LEXINGTON-FAYETTE URBAN COUNTY GOVERNMENT CONTRACT CHANGE ORDER Page 1 of 11		Date:	October 1, 2025
To (Contractor):		Project:	Clays Mill Road Improvements, Section 1
L-M Asphalt Partners, Ltd.		Location:	CMR - Waco to Harrodsburg
dba ATS Construction		Contract No.	17-2020
3009 Atkinson Ave, Suite 400, Lexington, KY 40509		Original Contract Amt.	\$10,683,653.39
		Cumulative Amount of Previous Change Orders	\$1,373,272.58
		Percent Change - Previous Change Orders	12.85%
		Total Contract Amount Prior to this Change Order	\$12,056,925.97
		Change Order No.	5 - Final
You are hereby requested to comply with the following changes from the contract plans and specification;			
Current Change Order

LEXINGTON-FAYETTE URBAN COUNTY GOVERNMENT CHANGE ORDER				DATE:		October 1, 2025
Change Order #:						5 - Final
CONTRACT #:						17-2020
Project: Clays Mill Road Improvements, Section 1						
You are hereby requested to comply with the following changes from the contract plans and specifications;

Clays Mill Road Improvements, Section 1
Change Order No.5 - Final
Reasons for Porposed Changes

Clays Mill Road
Lane Allen to Harrodsburg Closures

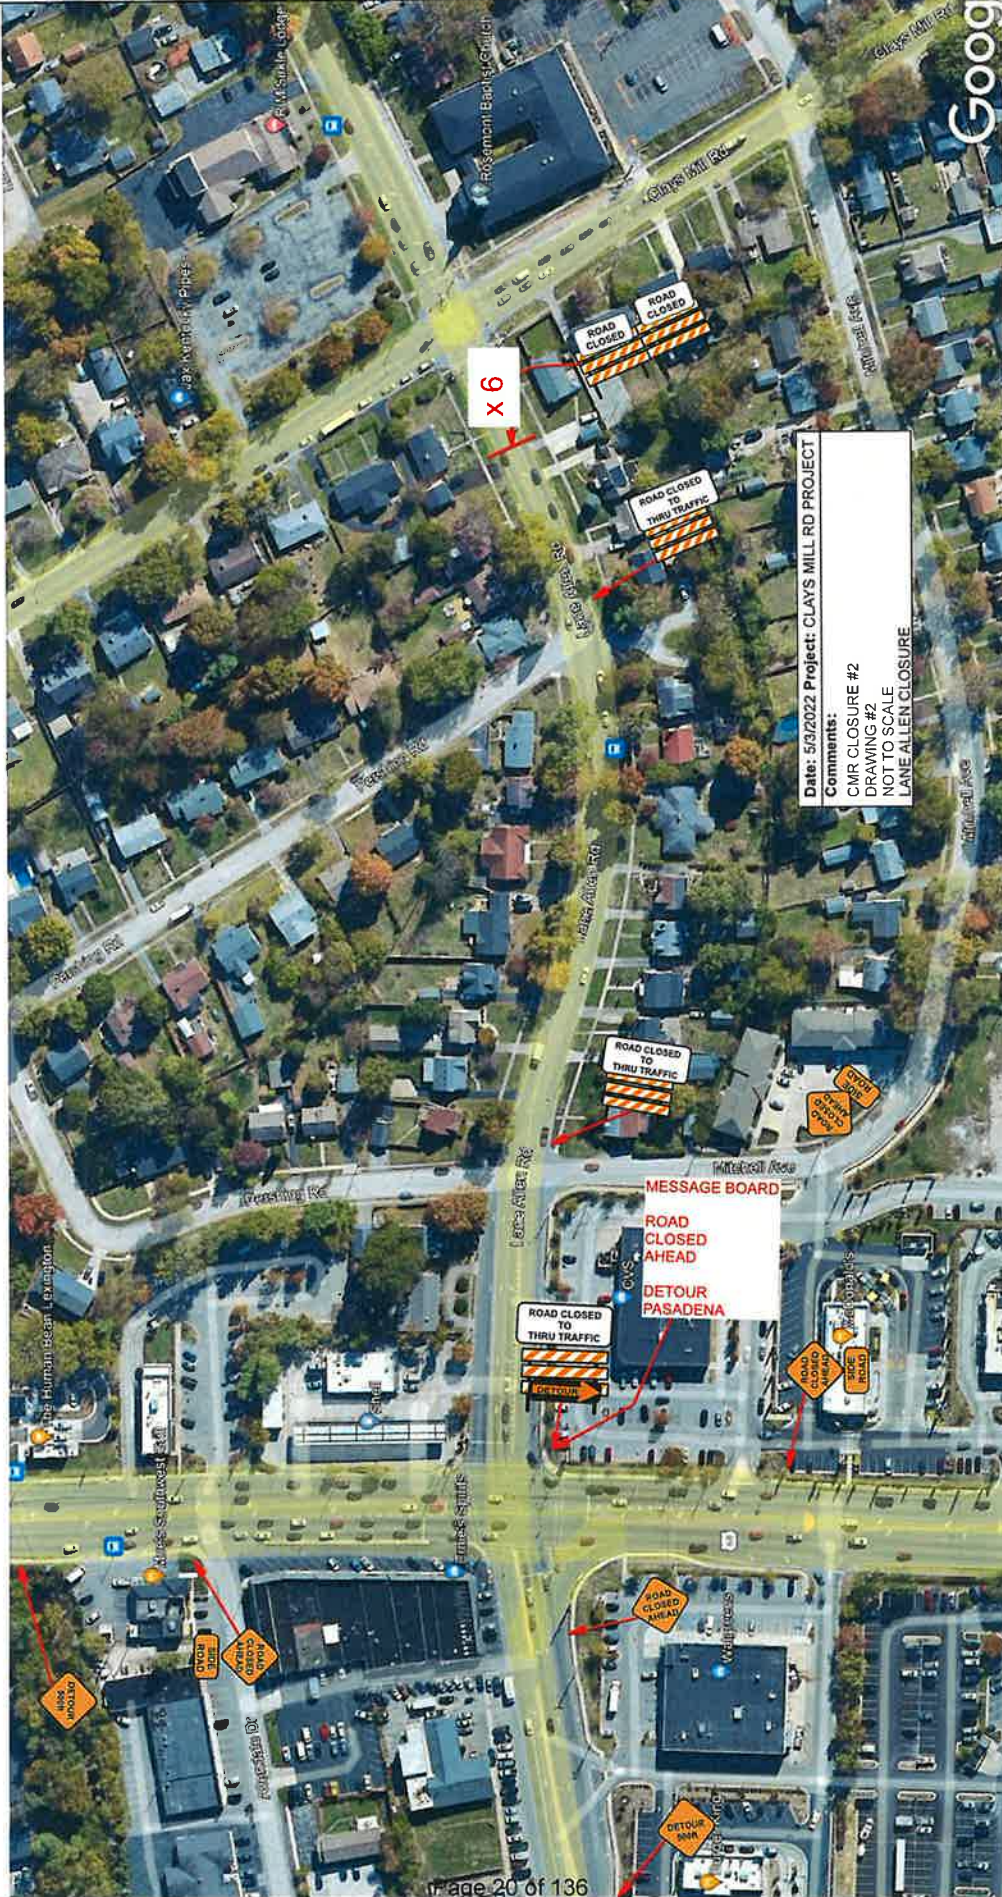
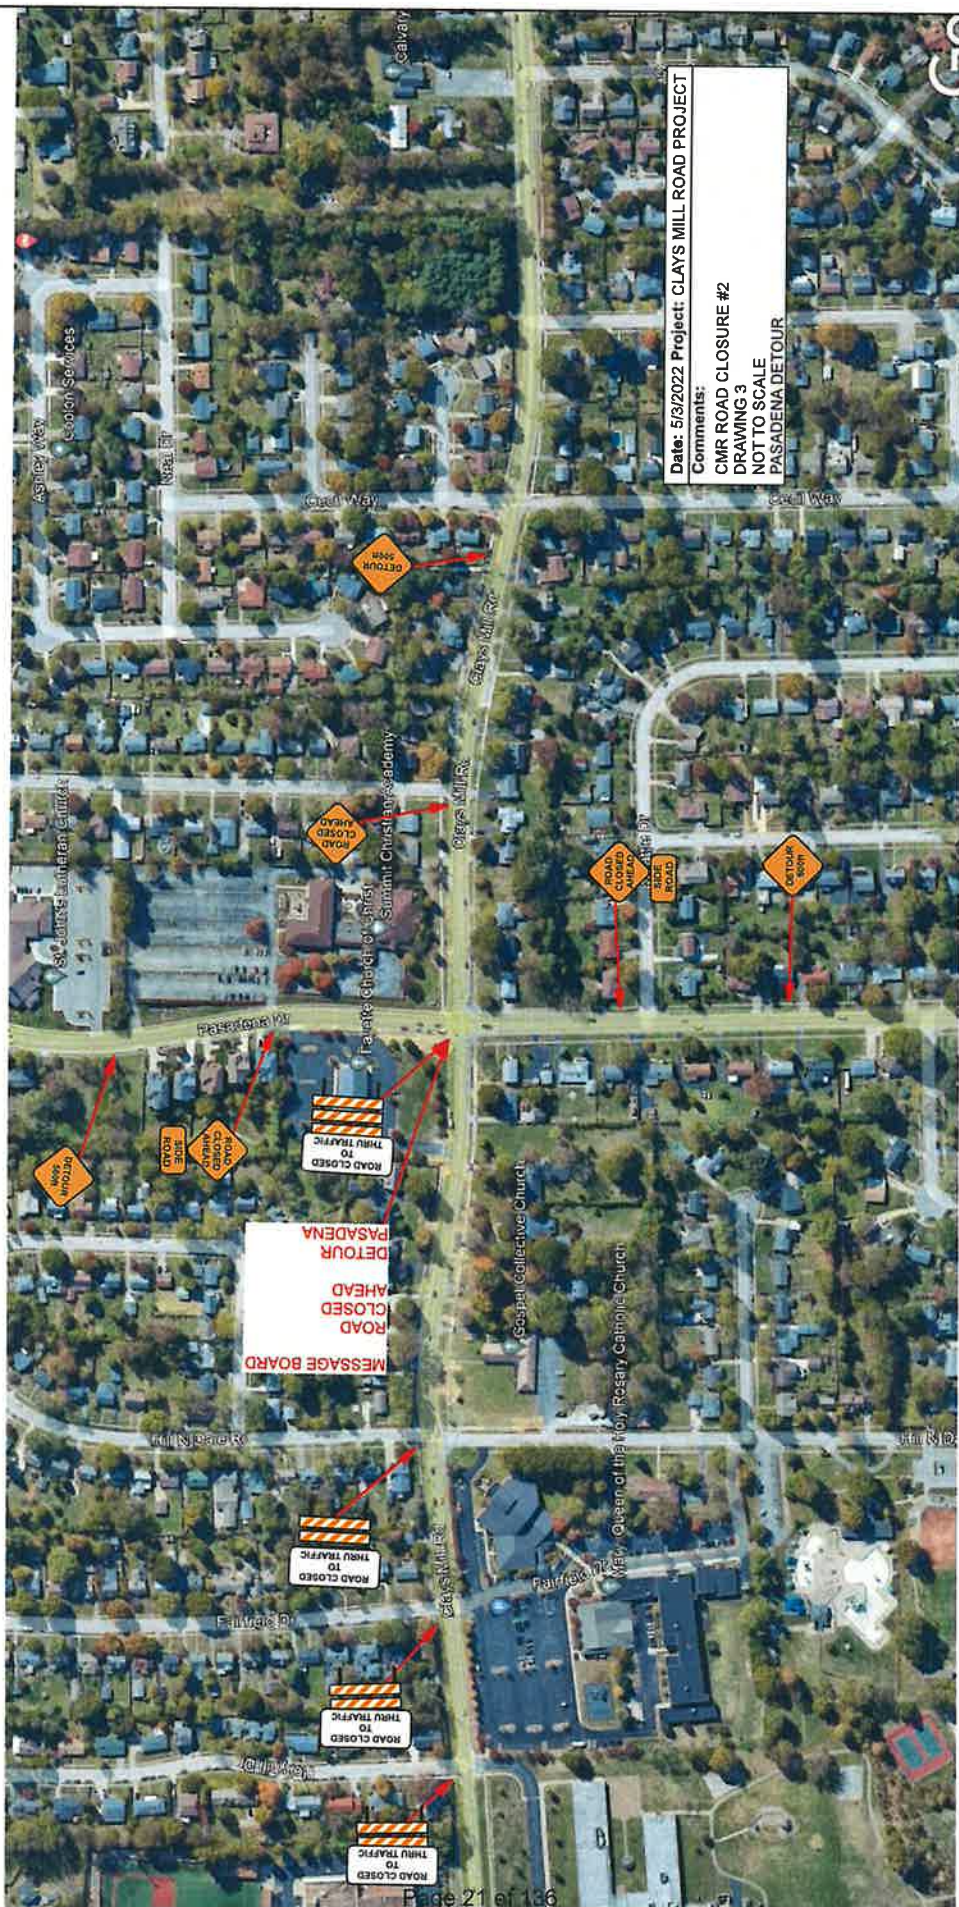
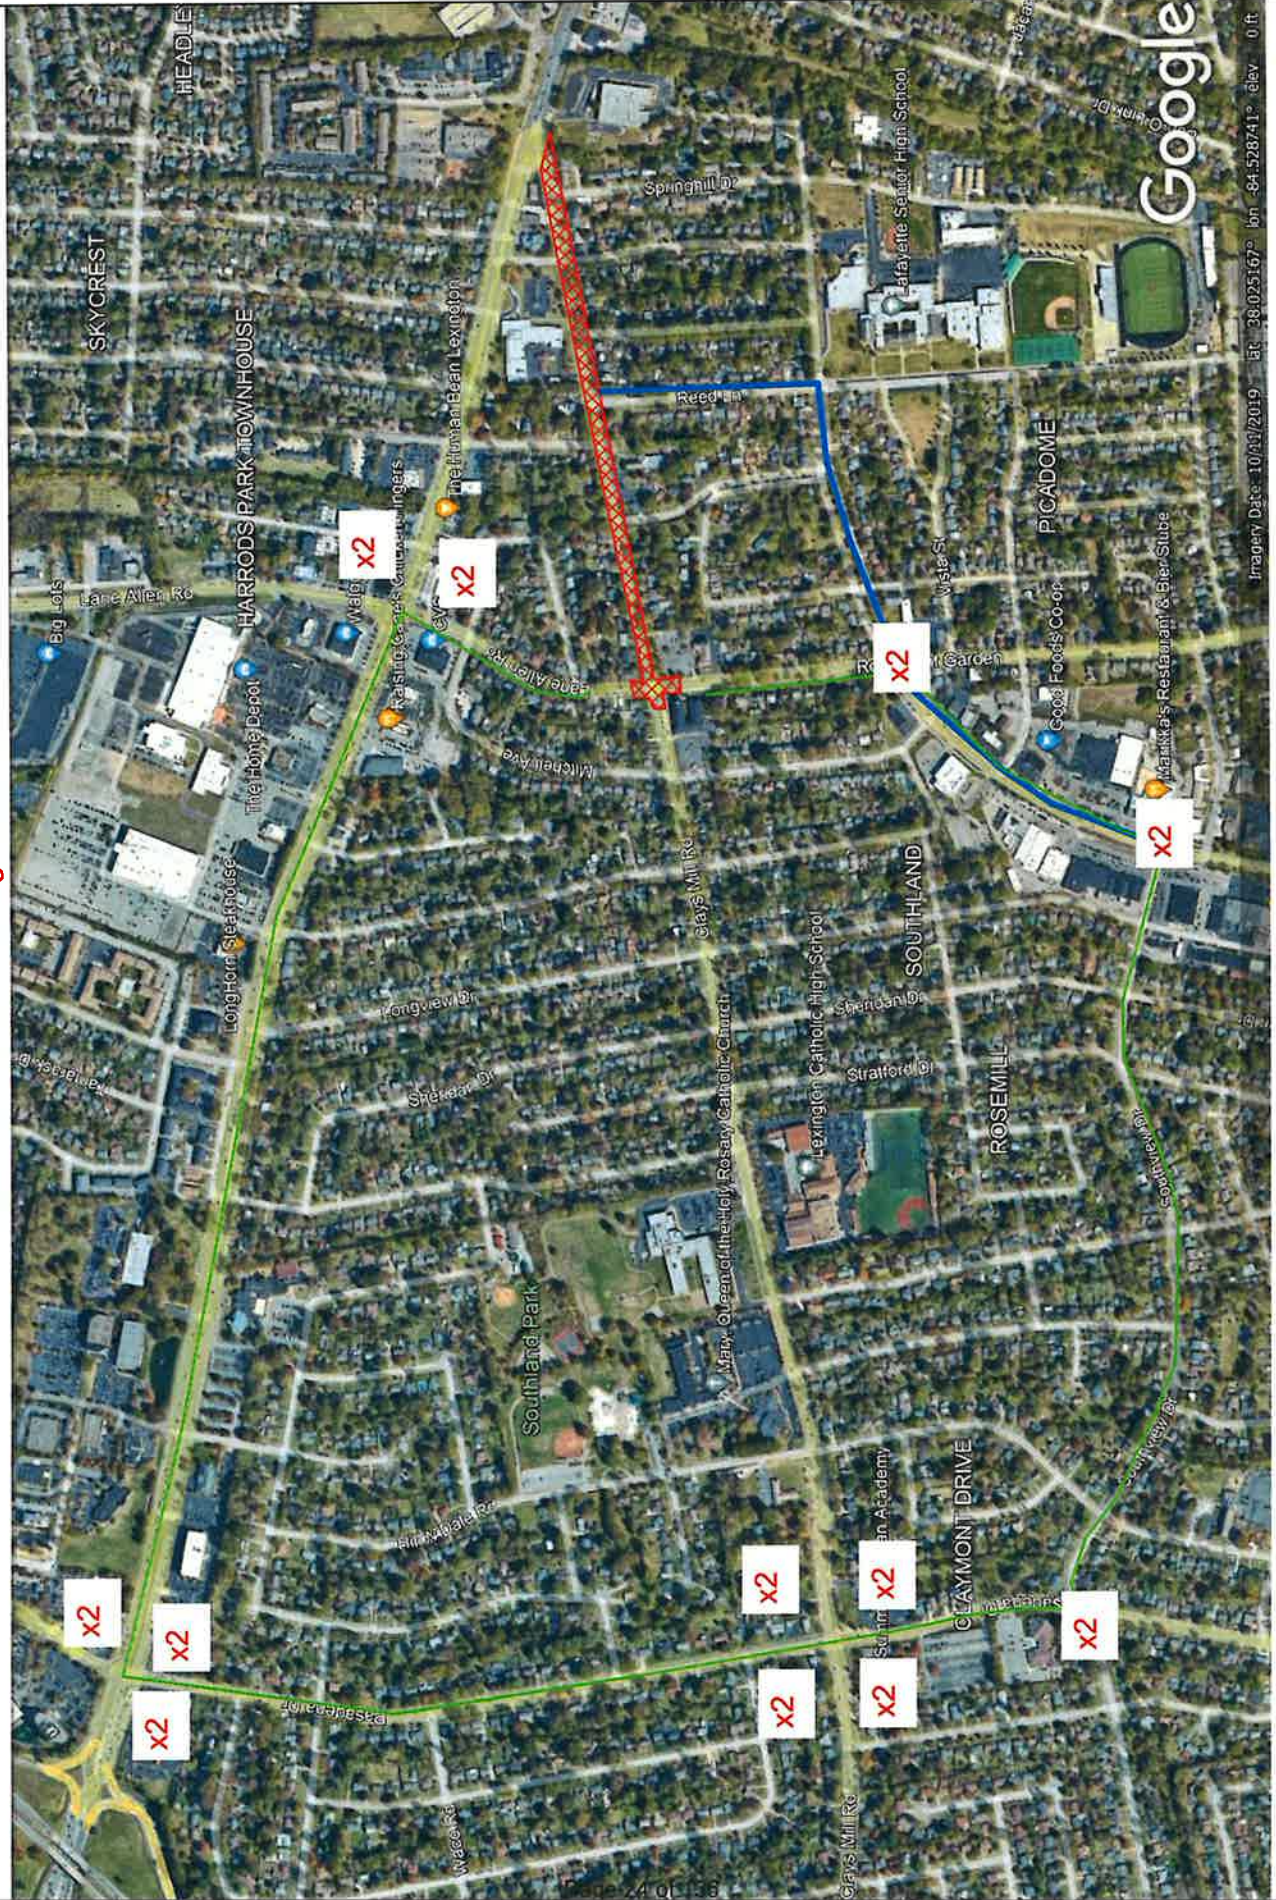
In a letter dated June 24, 2023 (attached), supplemental pricing was provided for the closure of the Clays Mill Road and Lane Allen intersection to complete both contractual work and utility relocations. This proposal has been modified based on the attached closure plan and summaries and includes subsequent closures to Harrodsburg Road.

Revised proposal below based on quantities of the attached closure plan.

Clays Mill Road Waco to Pasadena Northbound Closure

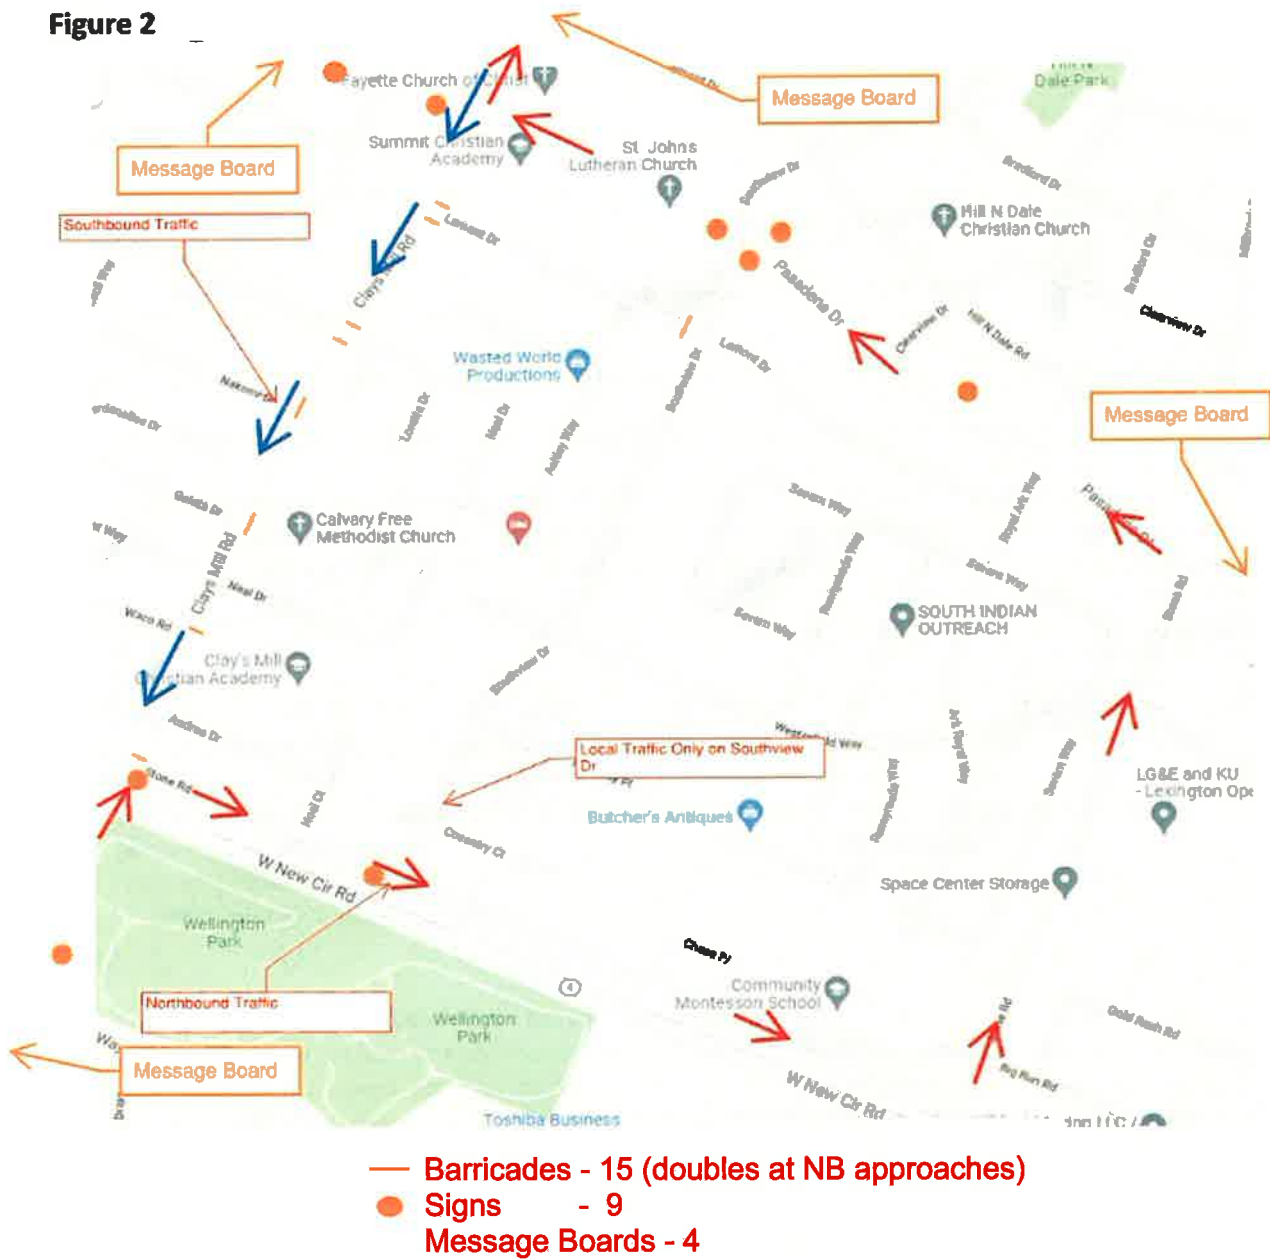
The purpose of this letter is to revise the supplemental proposal submitted on 6/24/2023 based on the attached signage plan. The quantities below reflect the amount of additional MOT used to detour Northbound traffic around Clays Mill Road from Waco Dr to Pasadena Dr.

1892 CMR
Image 1 of 2

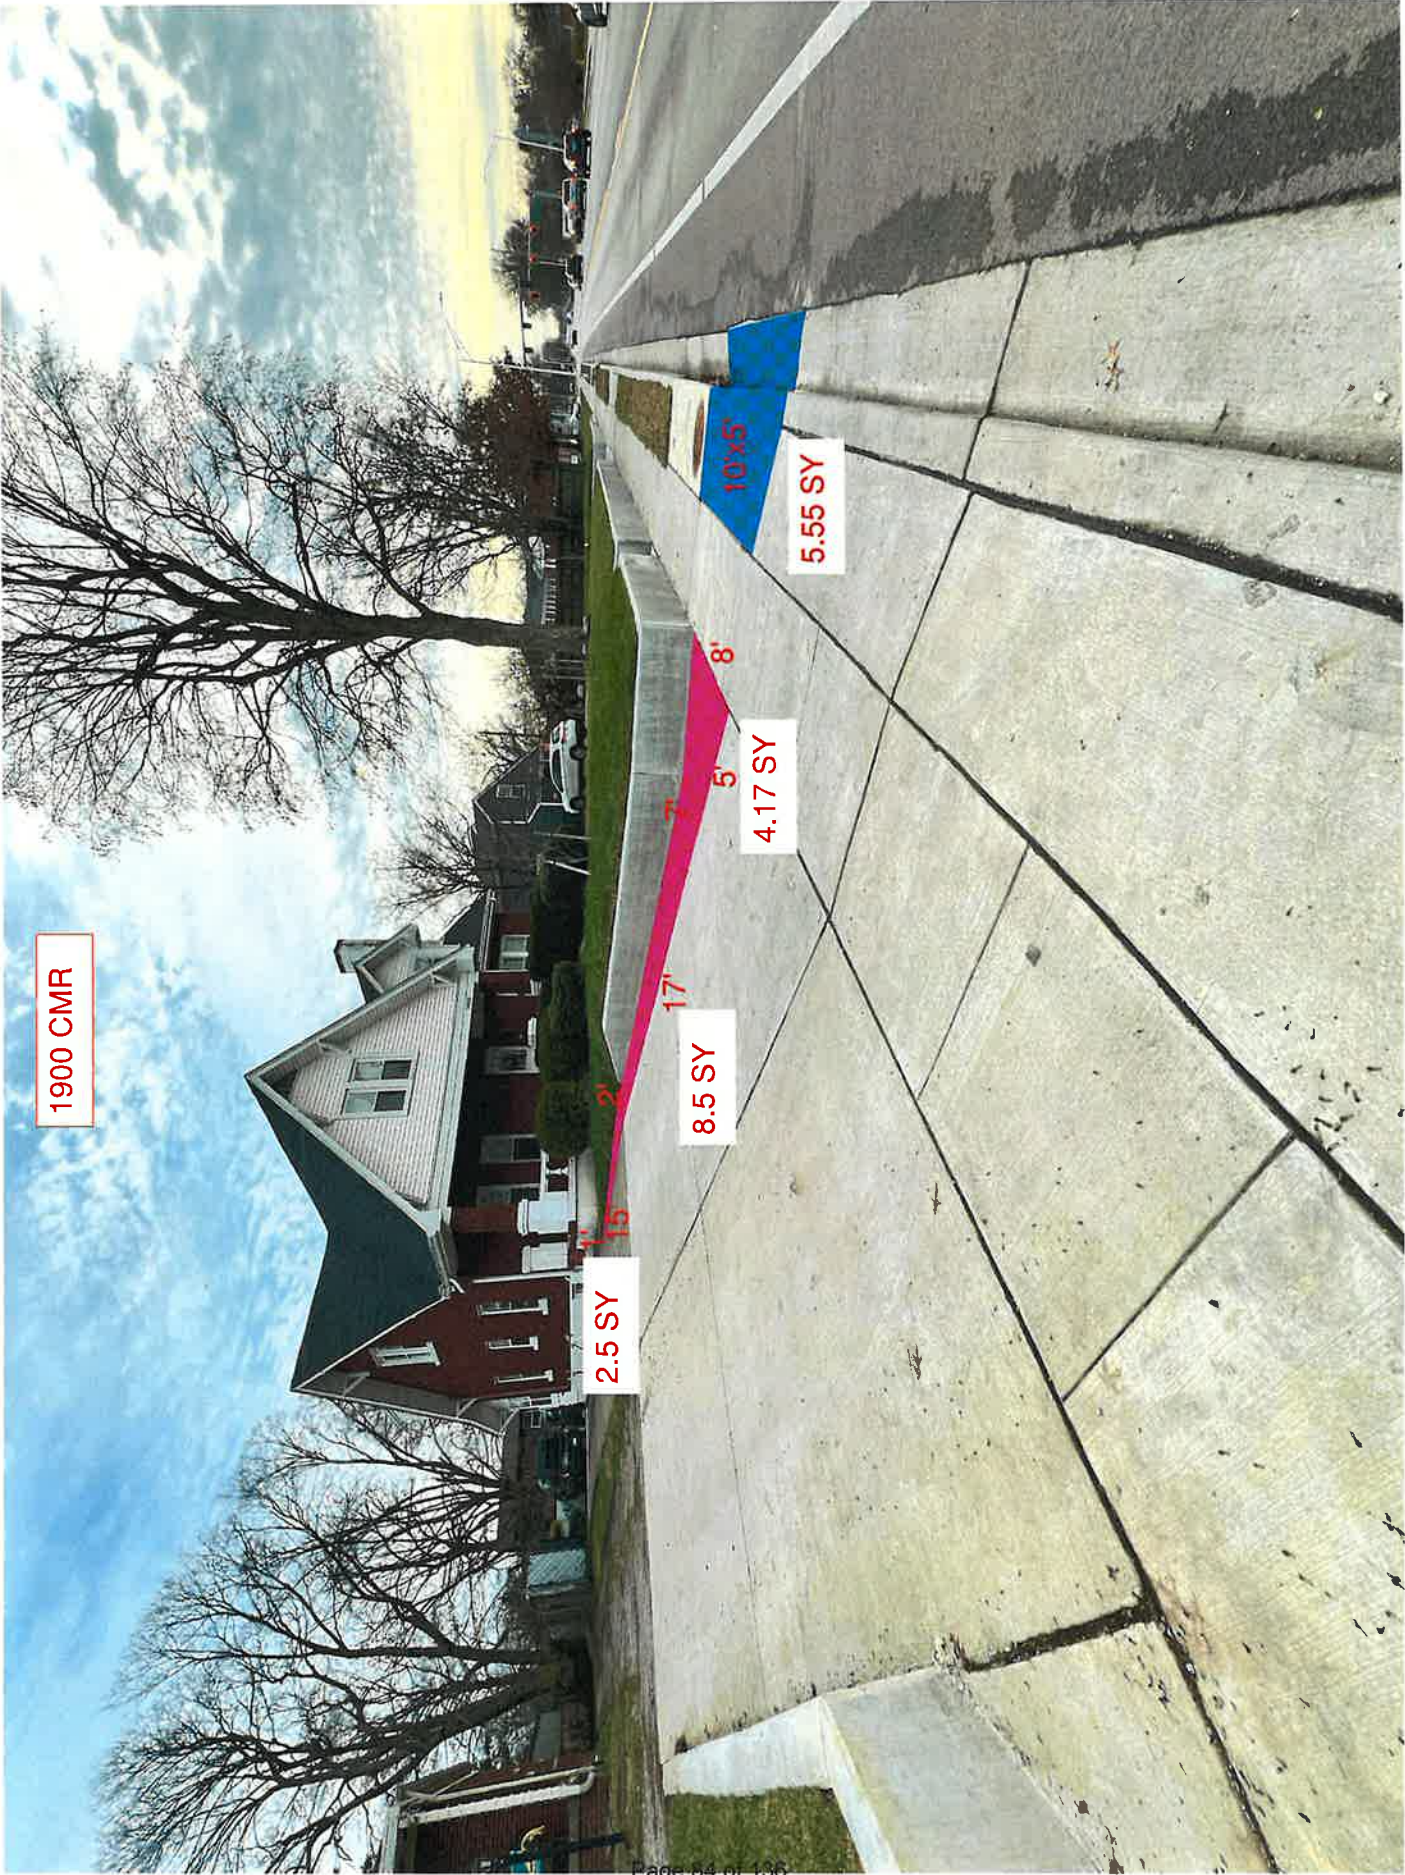
In conjunction with the retaining wall revisions change order proposal (ref # 10099), ATS Construction submits the following pricing for additional driveway pavement completed because of the retaining wall revisions. The pricing is broke out between new entrance pavement and entrance pavement that was removed and replaced. Photos and area breakouts are attached to this letter (Pink=New Pavement, Blue=Remove & Replace). Both options have previously agreed upon pricing.
